THE CITY OF AMERICAN CANYON
DEPARTMENT OF PUBLIC WORKS

**ENGINEERING STANDARD
PLANS AND SPECIFICATIONS
FOR
PUBLIC IMPROVEMENTS**

MAY 1, 1995

ENGINEERING STANDARD PLANS & SPECIFICATIONS

CURB AND GUTTER

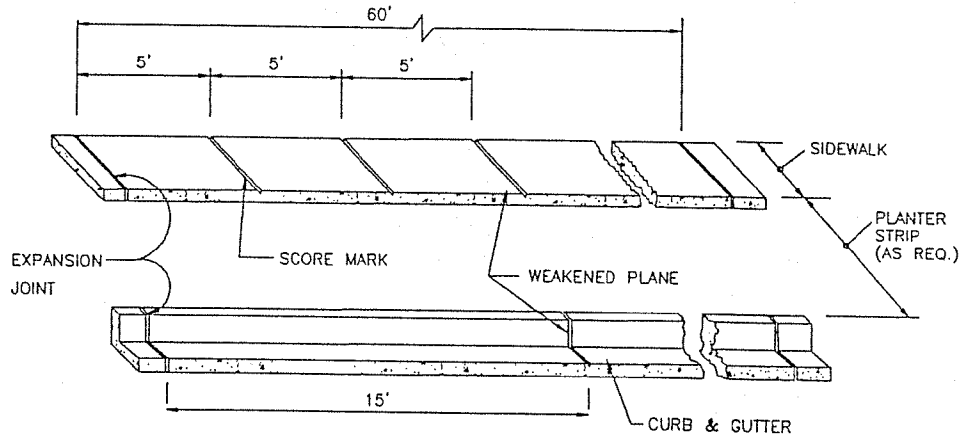
Standard Drawing No. 3.06 and 3.07- disregard 2% slope callout in gutter pan.

Standard Drawing No. 3.07 -4 ¾" dimension shown shall be from top of asphalt at gutter lip to top of curb (similar to Standard Drawing 3.06

Standard Drawing No. 3.07 – Polypropylene is not required.

Standard Drawing 3.06, 3.07 and 3.15 - All concrete surface finishes shall be a Class "A" finish per Section 51.

TRAFFIC SIGNS, URBAN DISTRICT TYPICAL INSTALLATION

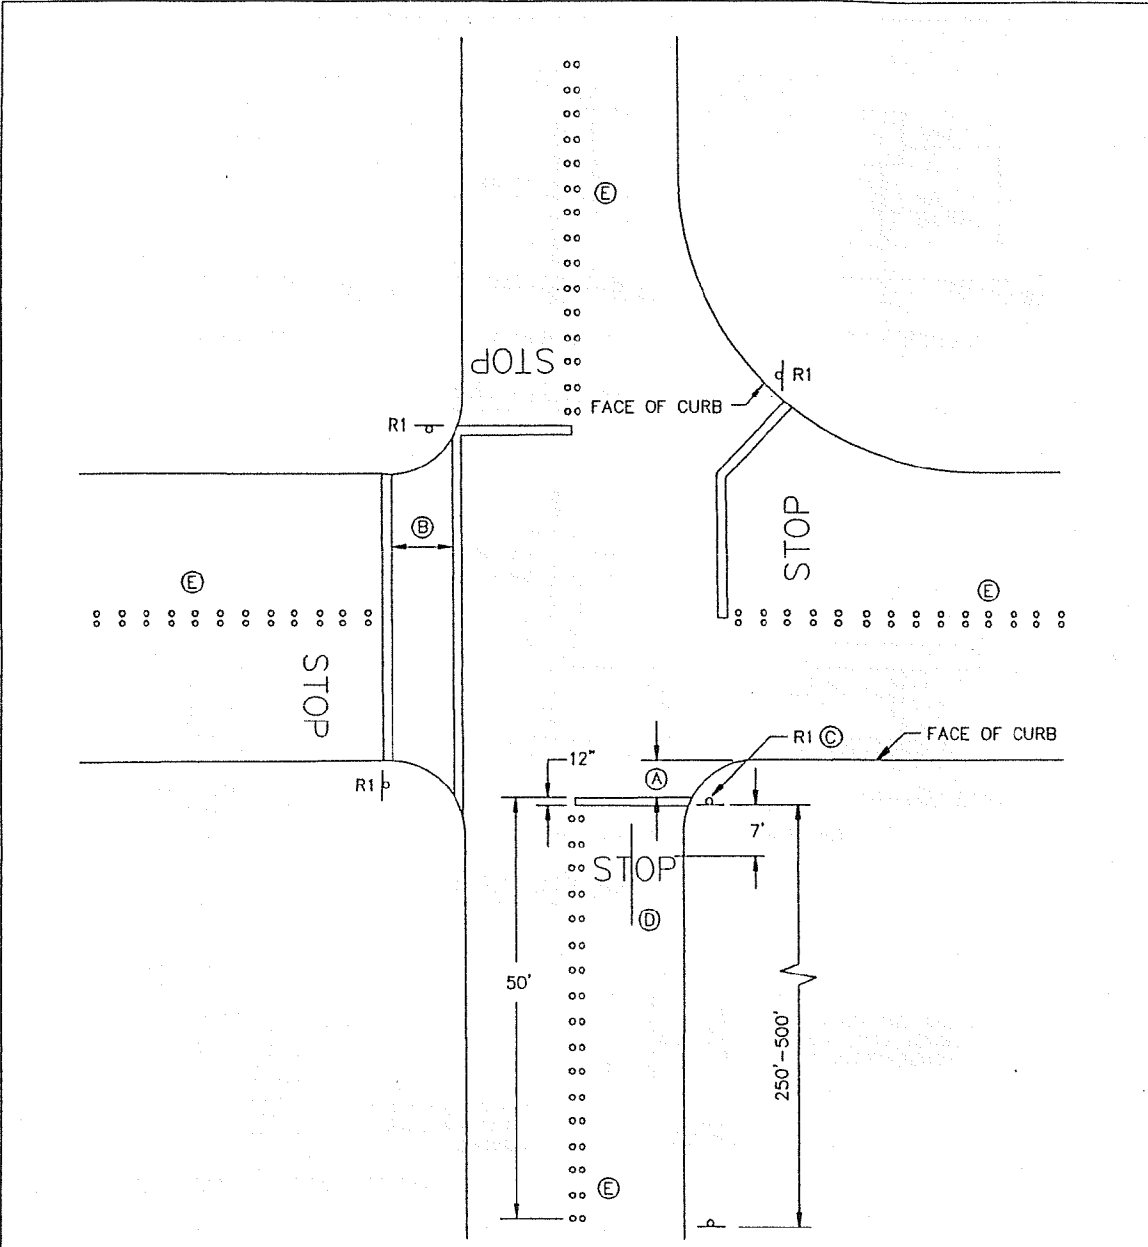
Standard Drawing No. 3.18 – U-bolt type mounting devices are acceptable.

DATE 5/1/95
SCALE NONE
STANDARD DWG. # 5.07

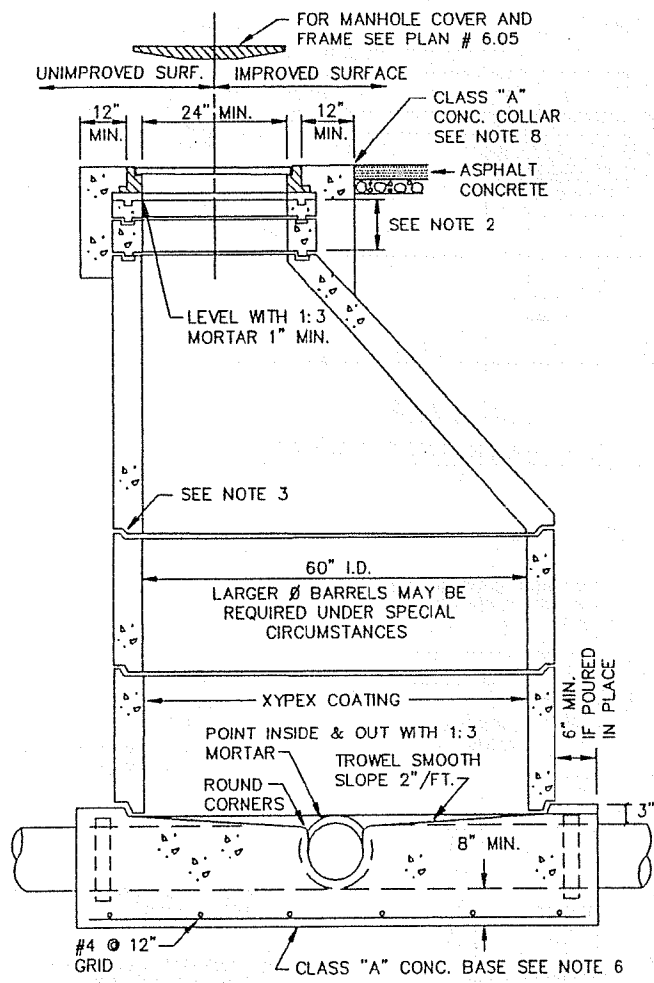
Standard Drawing No. 5.03, 5.04 and 5.07 - Fossil filters shall be required in all catchbasins unless otherwise noted on the plans.

DATE	5/1/95
SCALE	NONE
STANDARD DWG. #	7.01

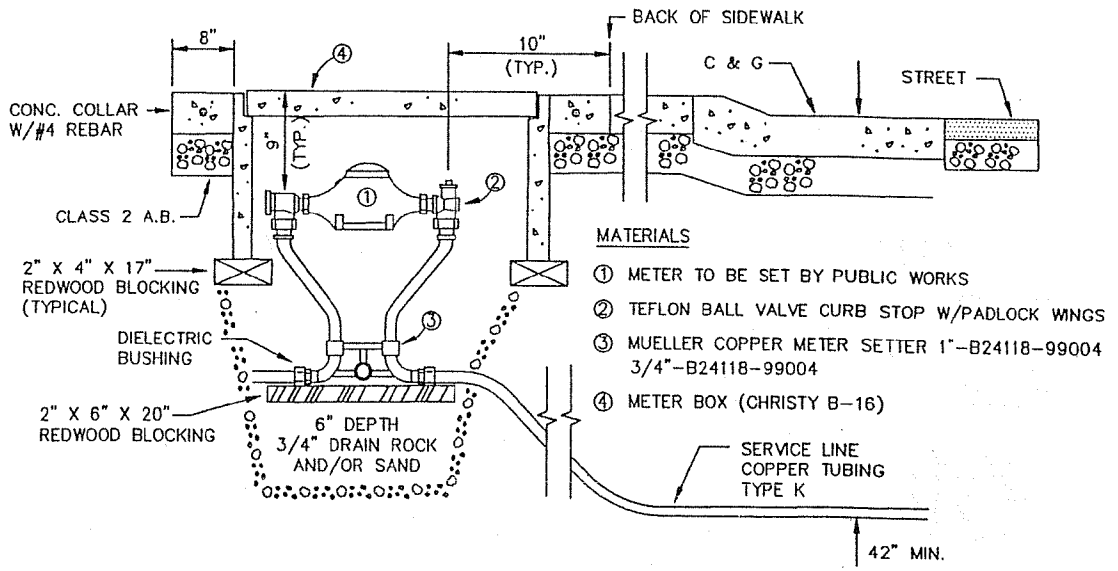
Standard Drawing No. 7.02 and 7.03 – When meters are not yet installed, curb stops shall be shut off and a cable tie installed in the top of the curb stop; cutting or tampering of the cable tie will constitute a straight tie-in connection, subject to penalties.

FIRE HYDRANT
INSTALLATION WATER
DISTRIBUTION SYSTEM

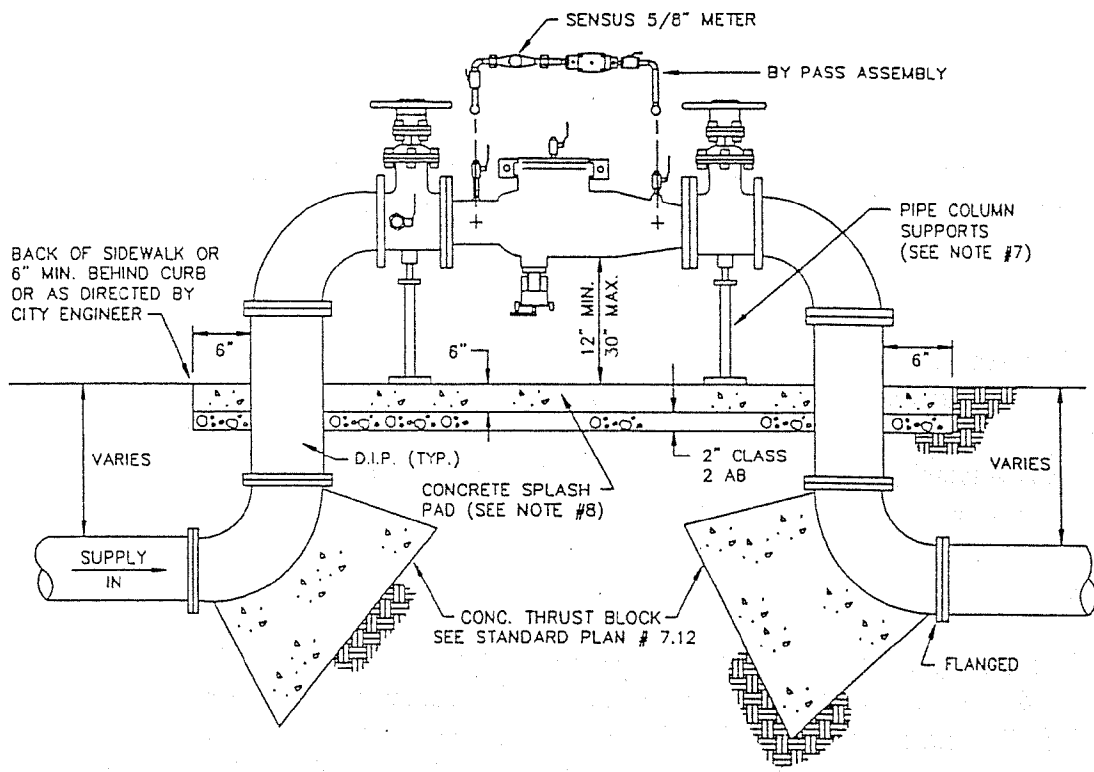
The following changes have been made to City Standard Detail 7.07, "Fire Hydrant Installation, Water Distribution System."

1. Hydrants shall be painted "safety yellow."
2. Concrete pier blocks are required, rather than 2"x8" redwood block.
3. Break-away hydrant bolts are no longer required at the check valve.
4. Long Beach #615 is no longer on the approved list of hydrants.
5. Disregard detail note #5.

Standard Drawing No. 7.07 – Replace 2"x8" redwood blocks with concrete piers
Fire hydrant to be painted safety yellow
Eliminate breakaway hydrant bolts.
Delete note #5 and support bars.
Pipe is 6" ductile iron pipe.
Delete Long Beach #615 fire hydrant option.

GENERAL NOTES

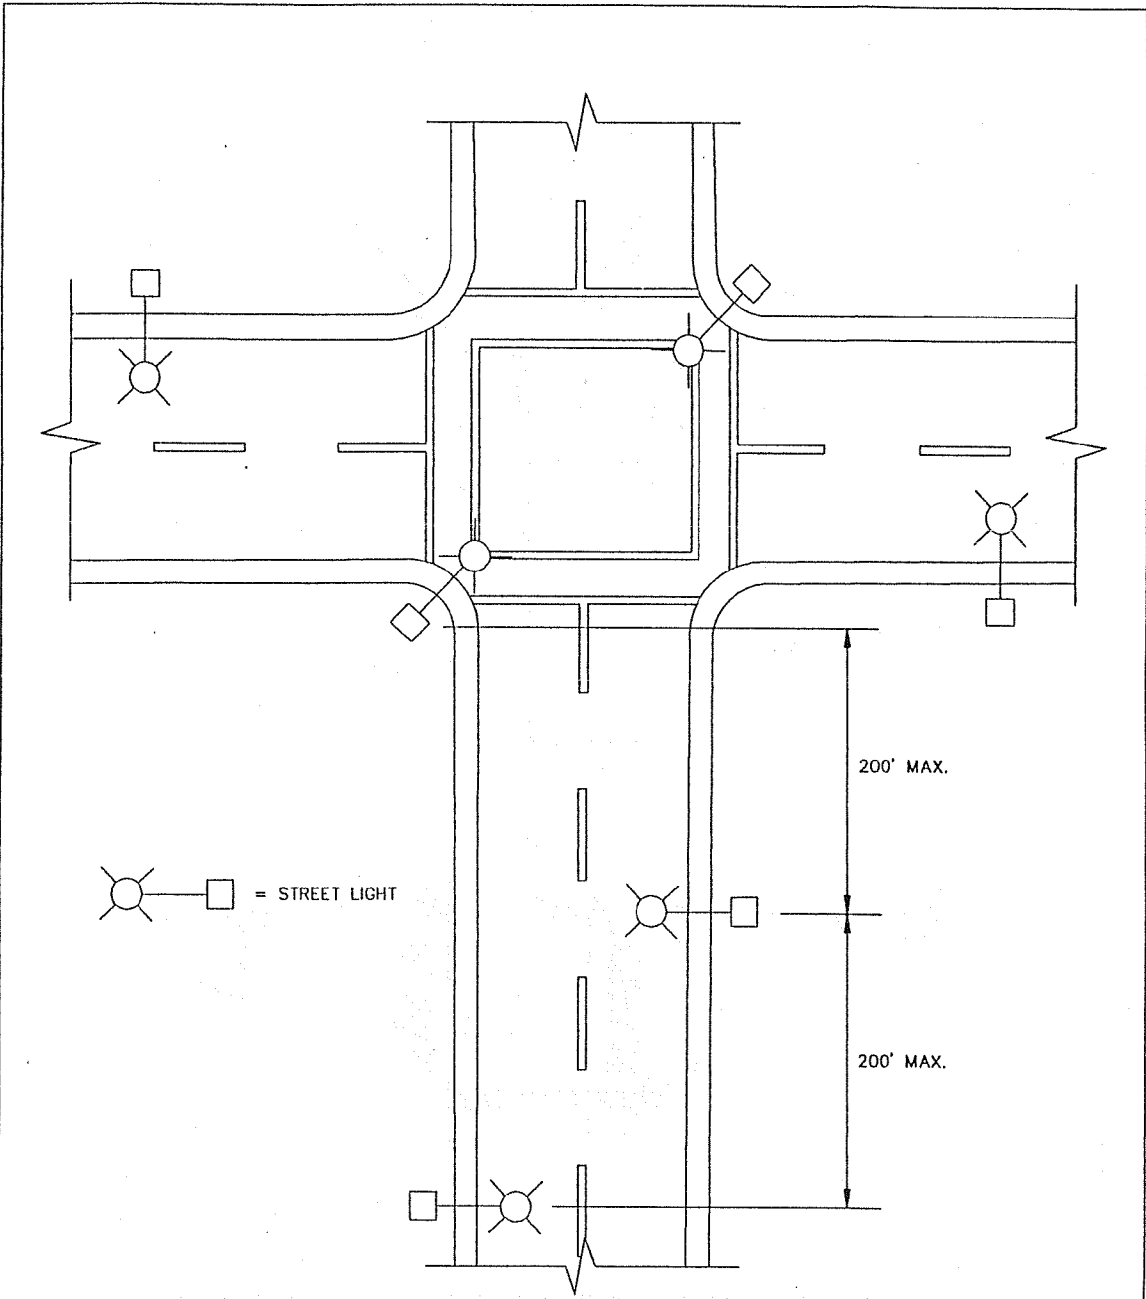
Standard Drawing No. 8.01 - Hand holes shall be located on the down stream side of the pole in relation to traffic flow

DATE	3/1/95
SCALE	NONE
STANDARD DWG. #	10.04

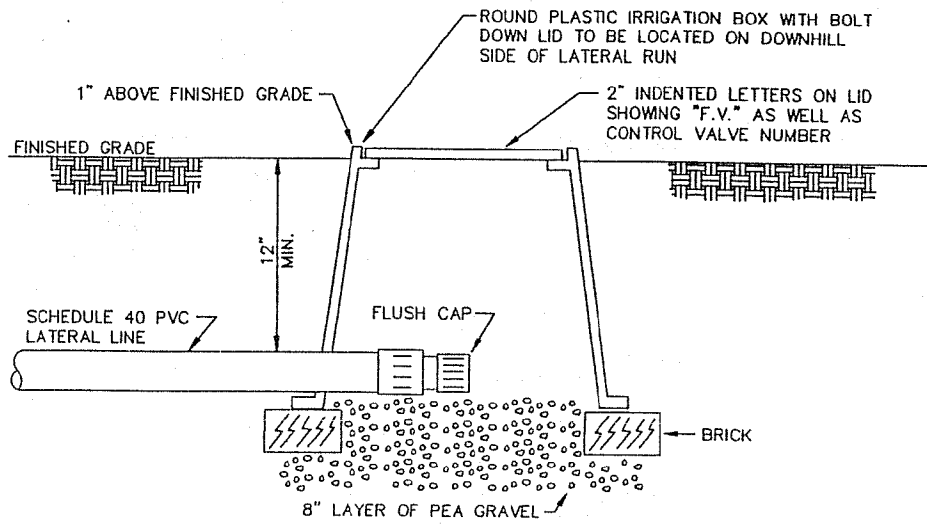
Standard Drawing No. 10.04 - Irrigation piping shall be purple pipe, minimum schedule 40.
